## PLAN COMMISSION

**BLOOMINGTON PLAN COMMISSION****STAFF REPORT – Second Hearing****Location:** 723 W. 1<sup>st</sup> Street, 709 W. 1<sup>st</sup> Street, 607 W. 1<sup>st</sup> Street**CASE #:** ZO2025-12-0018**DATE:** February 12, 2026**PETITIONER:** Bloomington Redevelopment Commission  
401 N. Morton Street, Suite 130, Bloomington, IN**CONSULTANT:** Alli Thurmond (Range Co/Flintlock)  
512 N. Mission Blvd, Fayetteville, AR**REQUEST:** The petitioner is requesting to rezone approximately 6.3 acres to Planned Unit Development and a request for approval of a District Ordinance and Preliminary Plan.**BACKGROUND:****Area:** 6.3 acres

### Hopewell South Planned Unit Development (PUD)

# STREET SECTIONS

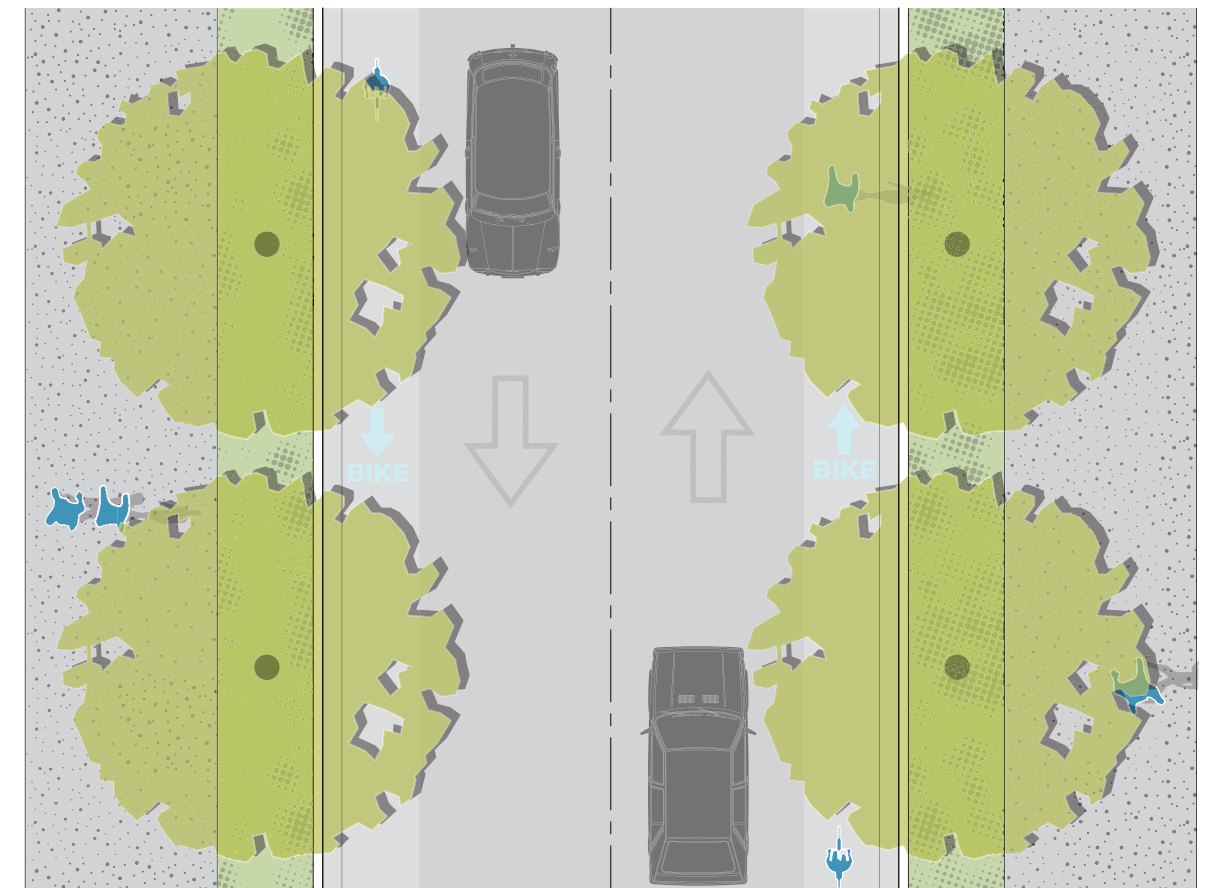
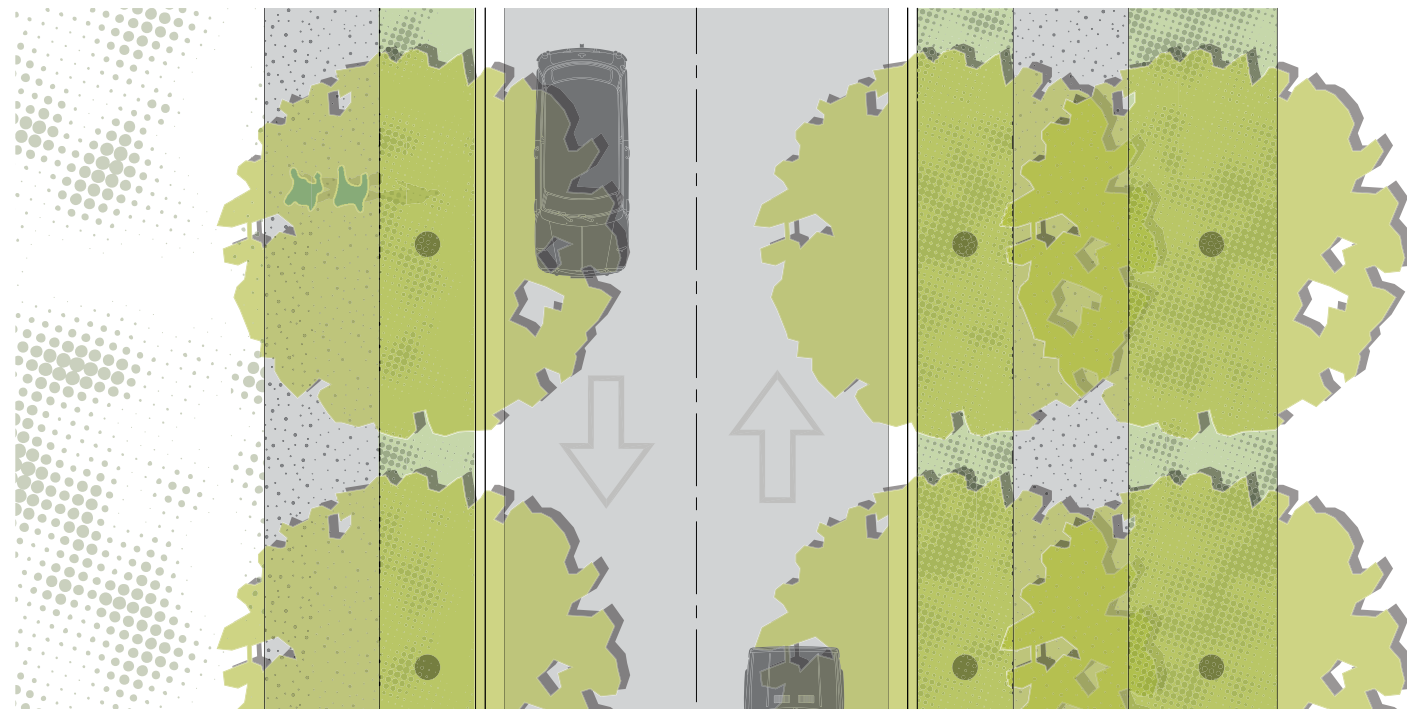
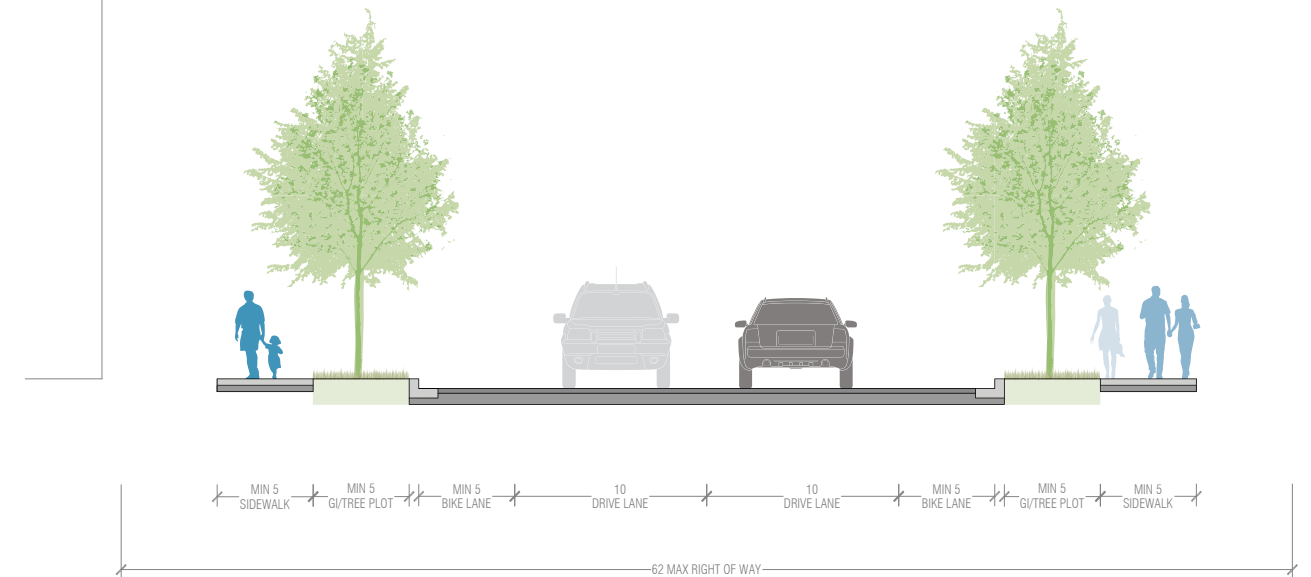
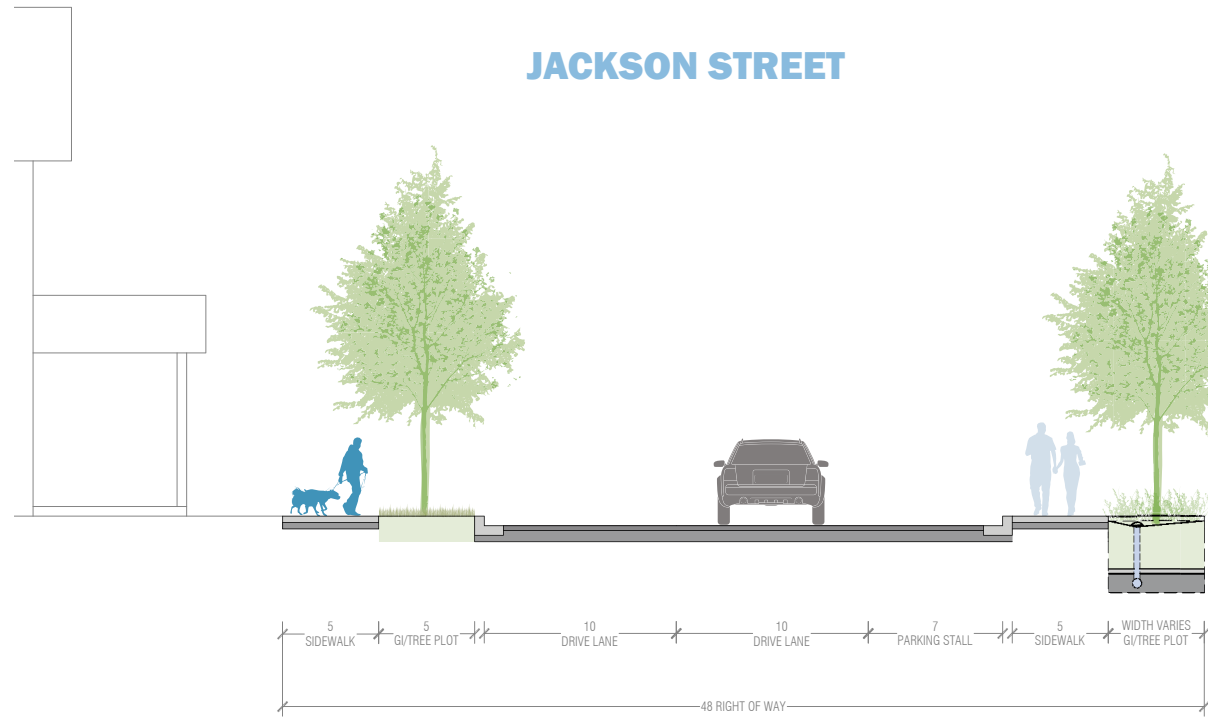
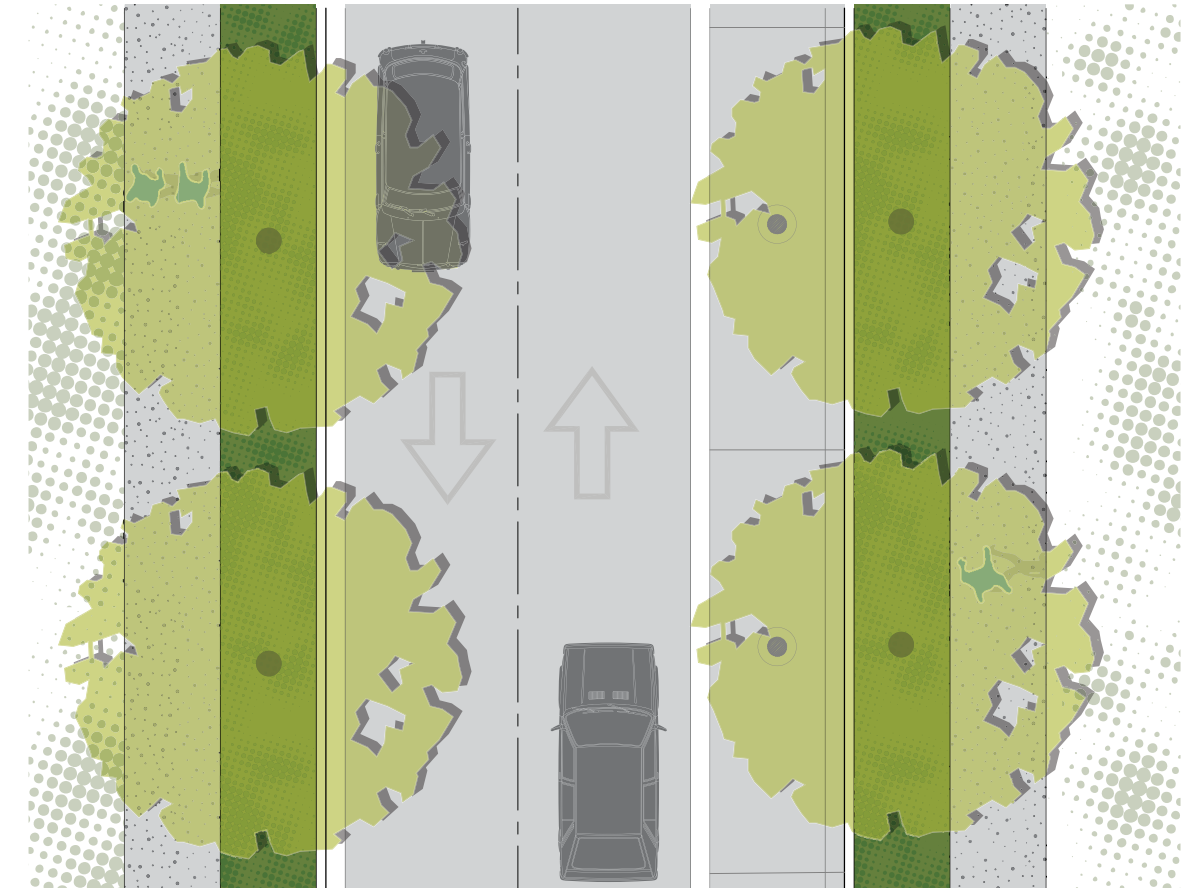
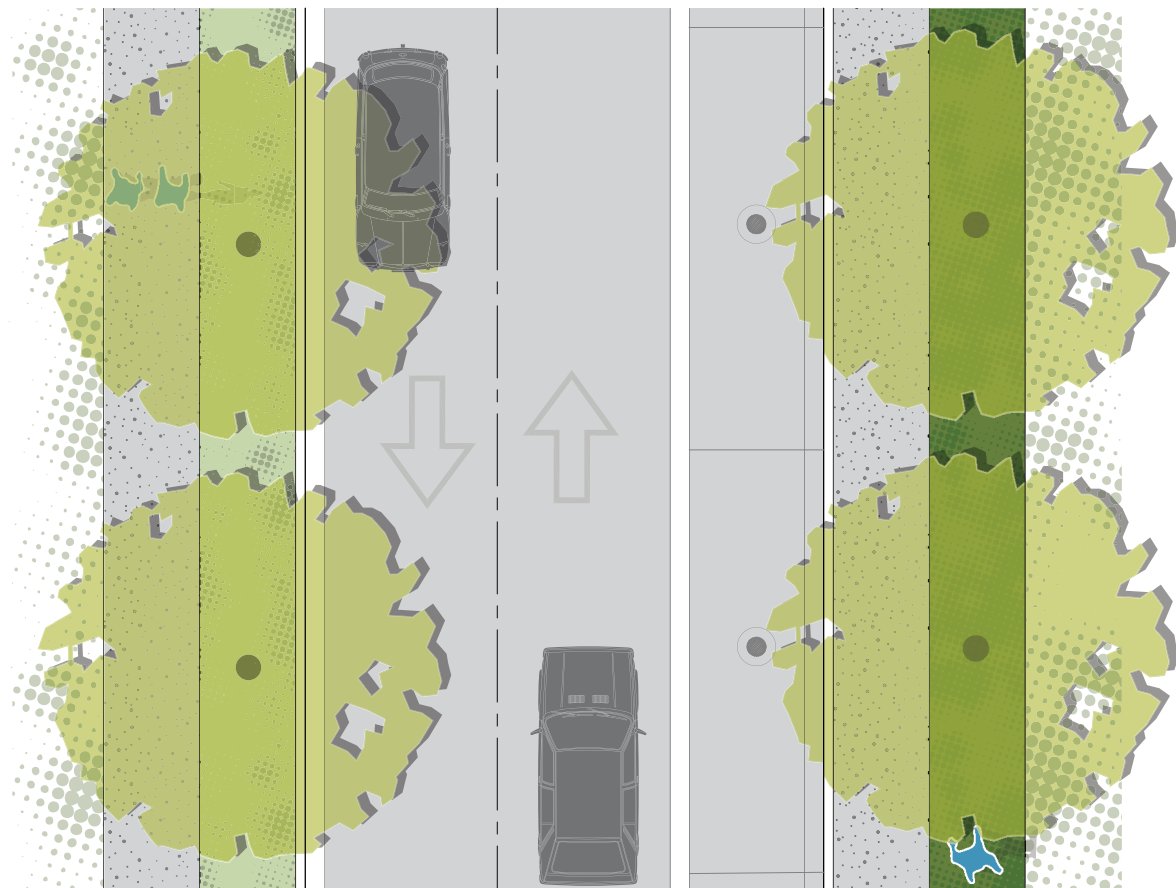
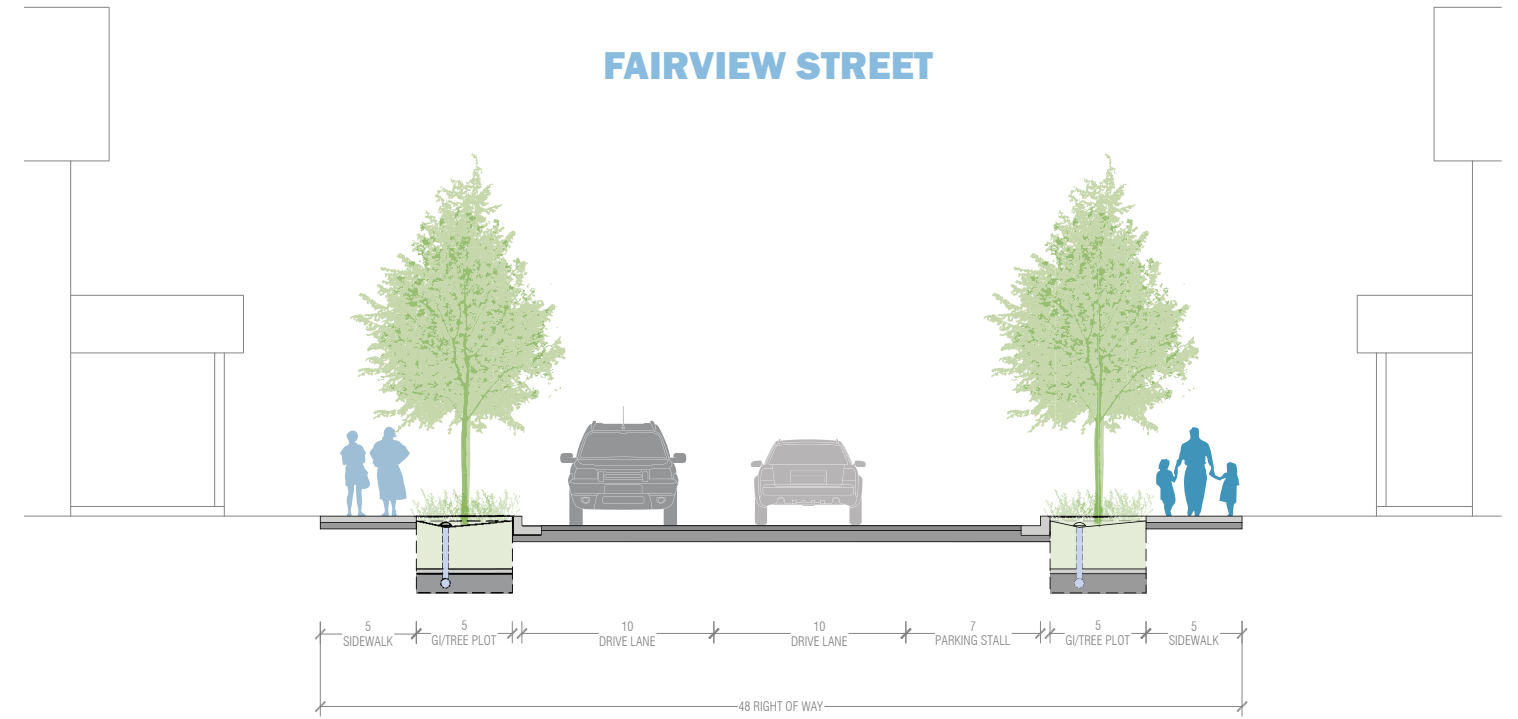
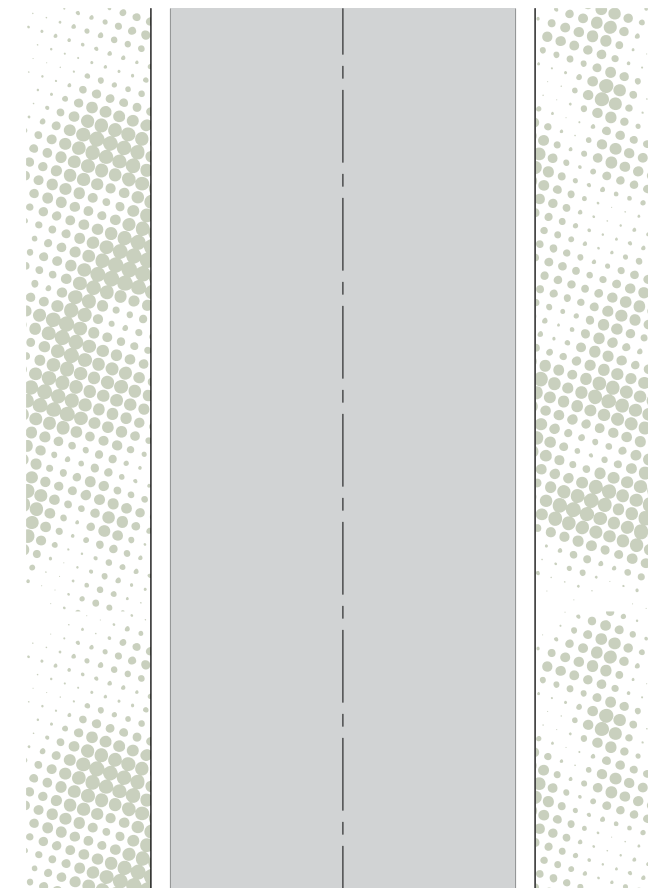
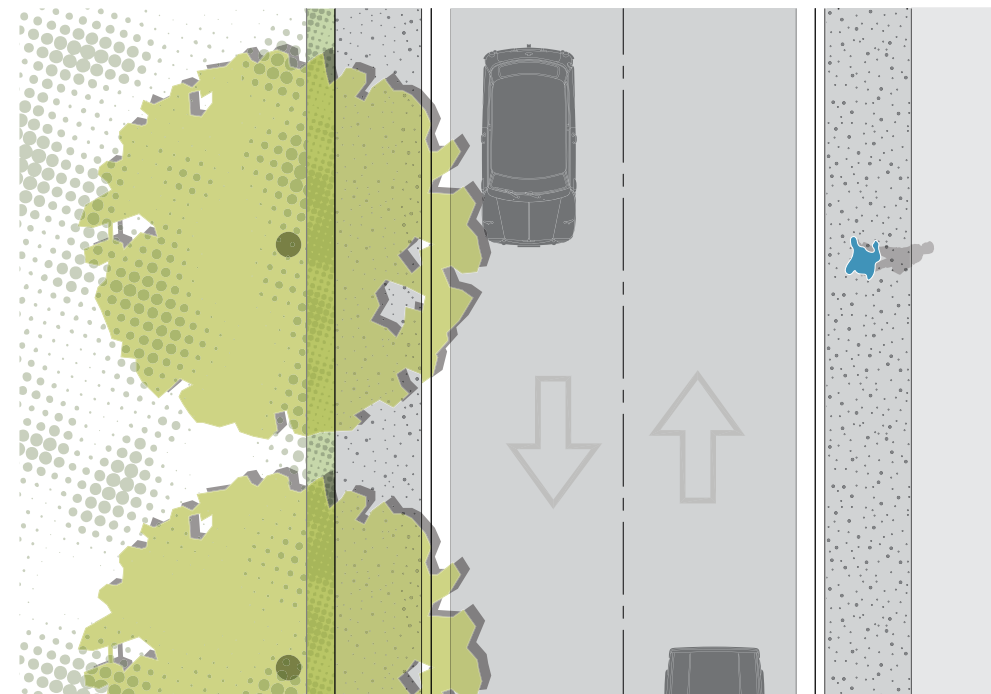
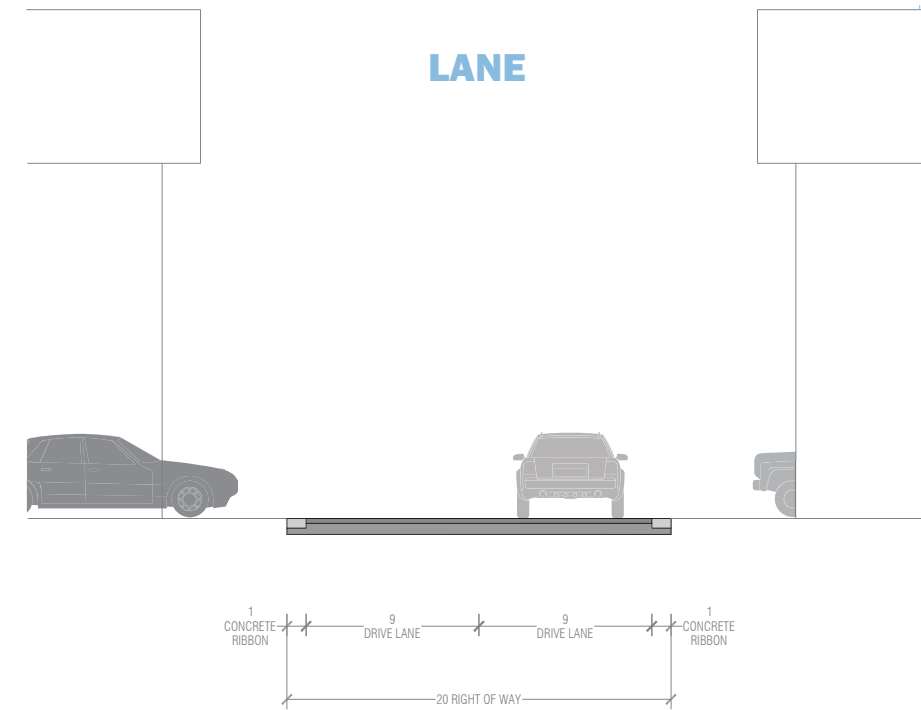
- The Transportation Plan would require a total 84' of right-of-way (42' from centerline). There is currently approximately 20-25' of right-of-way from centerline. The proposed cross section within the PUD for Rogers Street shows a dedication of 31' from centerline for right-of-way.

- Jackson Street
  - The Transportation Plan would require a total of 60' of right-of-way. With this petition Jackson Street would be constructed through this site to connect to 1<sup>st</sup> Street to the north and Wylie Street to the south. The City's recent improvements to 1<sup>st</sup> Street constructed an intersection along 1<sup>st</sup> Street for Jackson Street to connect to and it is in place. In order to maximize housing potential, while also balancing appropriate infrastructure needs, the petitioner is proposing a 48' right-of-way that would include 5' sidewalks and 5' tree plots on both sides, 2- 10' travel lanes, and a 7' wide on-street parking lane on the east side.

- Wylie Street
  - The Transportation Plan would require a total of 60' of right-of-way. But, of residential streets, the Plan also states "in order to preserve existing neighborhood fabric, existing streets shall not be required to conform to these cross-section standards". There is currently approximately 40' of right-of-way. The proposed cross section shows maintaining the existing right-of-way line with no additional dedication. There is currently an approximately 4.5' monolithic sidewalk along the north side of Wylie Street along this frontage that would be replaced with this petition with a monolithic 5' sidewalk. There is also on-street parking along the north side of Wylie Street along this property frontage which is proposed to remain. The proposed cross section shows maintaining the current monolithic sidewalk.

- Fairview Street
  - The Transportation Plan would require a total of 60' of right-of-way. Fairview Street currently extends through the site and would be removed and reconstructed with this proposal. In order to maximize housing potential, while also balancing appropriate infrastructure needs, the petitioner is proposing a 48' right-of-way that would include 5' sidewalks and 5' tree plots on both sides, 2- 10' travel lanes, and a 7' on-street parking lane on the east side.
